ALERT SERVICE BULLETIN

ASB No. AA-03017

REVISION A

- SUBJECT:** External Hoist Kits
P/Ns 412-130-XXX, 412-140-XXX or 412-150-XXX
- MODELS AFFECTED:** Bell Helicopter Textron 412, 412EP, 412CF,
Agusta AB412, AB412EP with the subject External
Hoist Kit installed.
- COMPLIANCE:** This bulletin shall be complied within 50 flight
hours of receipt.
- DESCRIPTION:** This Alert Service Bulletin is being issued in
response to an incident of electrical interference
with basic aircraft equipment (i.e. AHRS Gyro,
Generator, instruments, etc). This bulletin
provides the procedures and identifies the
materials required to accomplish a modification to
improve electrical bonding to preclude electrical
interference. This document is FAA/DER
approved.
- MANPOWER:** Approximately 2.0 hours.

Figure 1

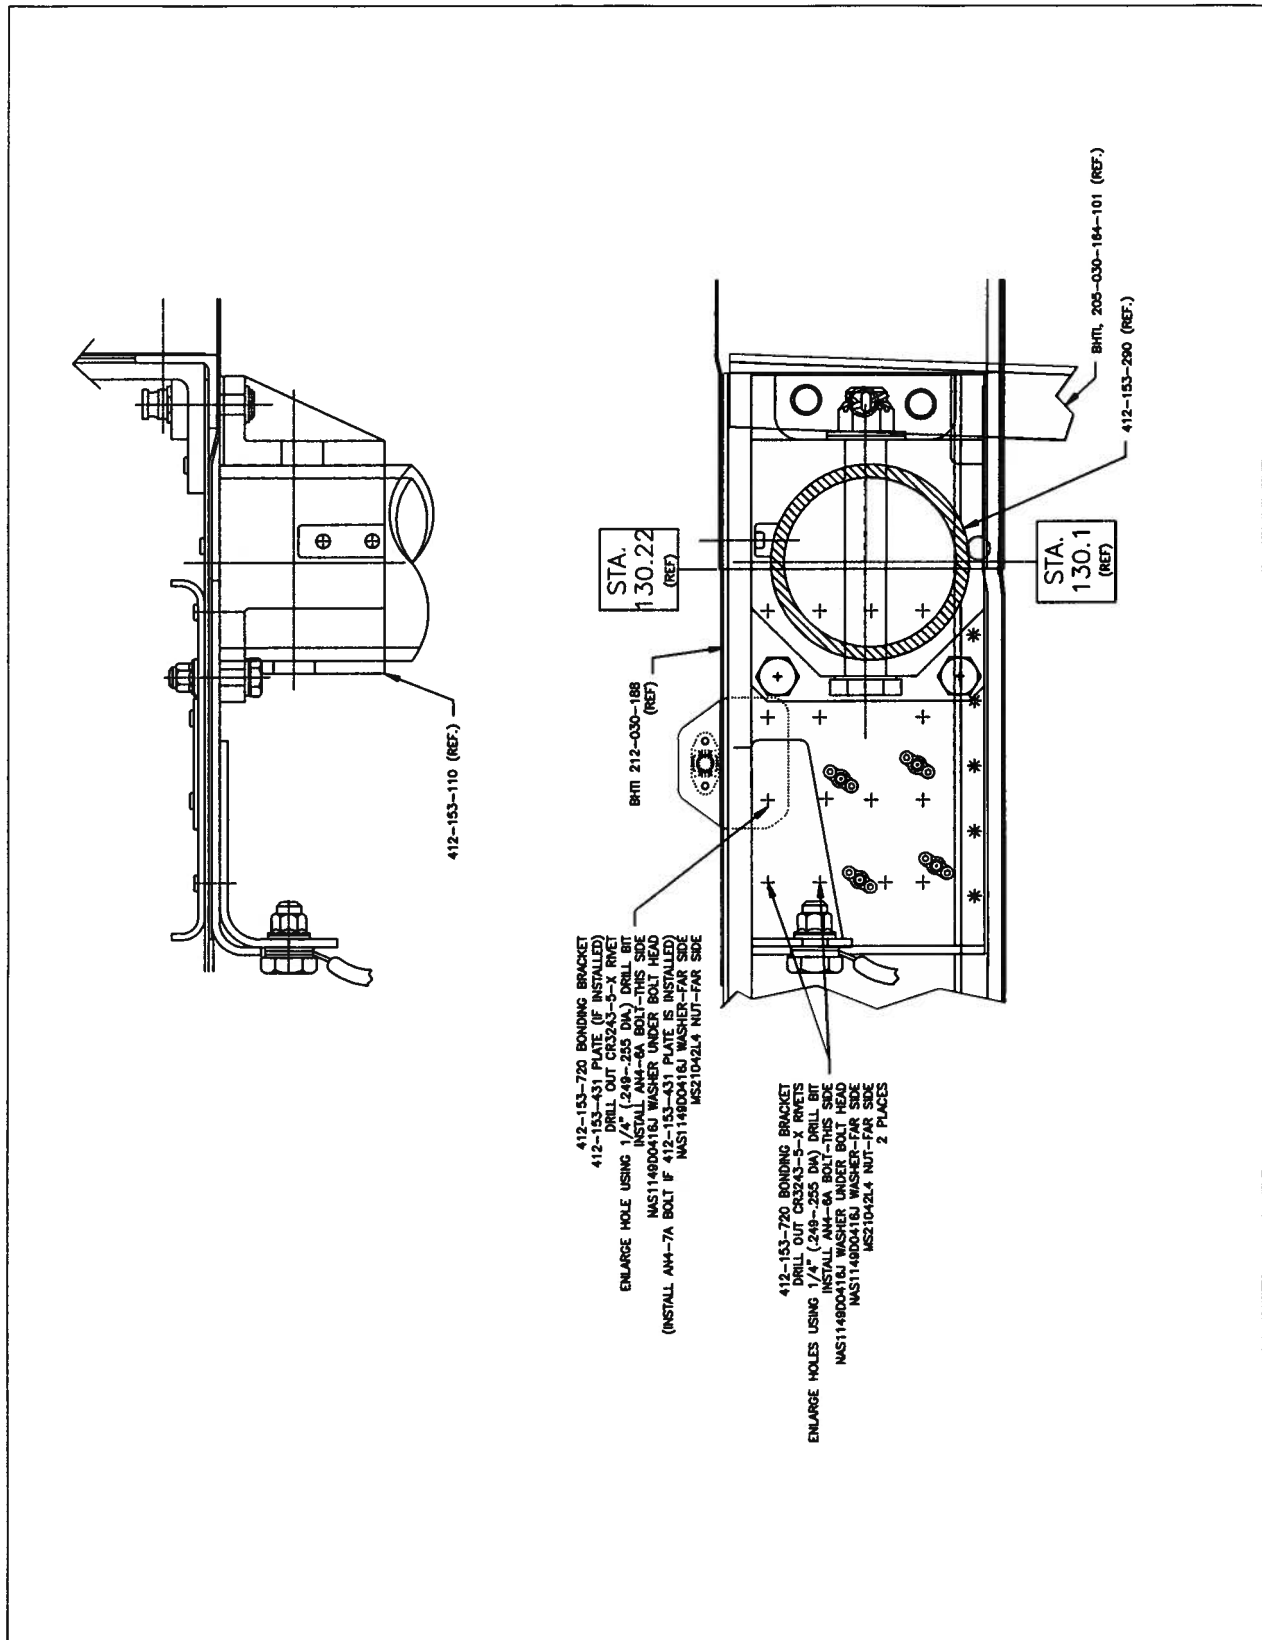
1. Locate Bonding Bracket (412-153-720) as shown in Figure 1.
2. Remove any existing blankets or trim to gain access to the area. Retain for reinstallation.
3. Drill out the three rivets attaching the Bonding Bracket to the airframe (Ref. Figure 1).

4. Increase the diameter of the three remaining holes by using a 1/4" (.249-.255 dia.) drill bit.

5. Using 100 grit sandpaper or dual action sanding, incrementally remove up to a maximum of .005 from the backside of the Bonding Bracket. Wipe the exposed surface with clean cheesecloth. The cheesecloth shall be either dry or wetted with isopropyl alcohol.

6. Apply a coating of chemical conversion coating (MIL-C-81706, Class 3 or equivalent) to the bond surface using a nonmetallic brush. Allow coating to remain on bond surface for 5 seconds maximum. This produces a light iridescent yellow finish on the bond surface.
7. Remove excess chemical conversion coating from the bond surface by blotting with a clean dry cheesecloth. Allow the bond surface to air-dry or gently wipe bond surface with cheesecloth.
8. Install Bolts, Washers and Nuts as shown in Figure 1.
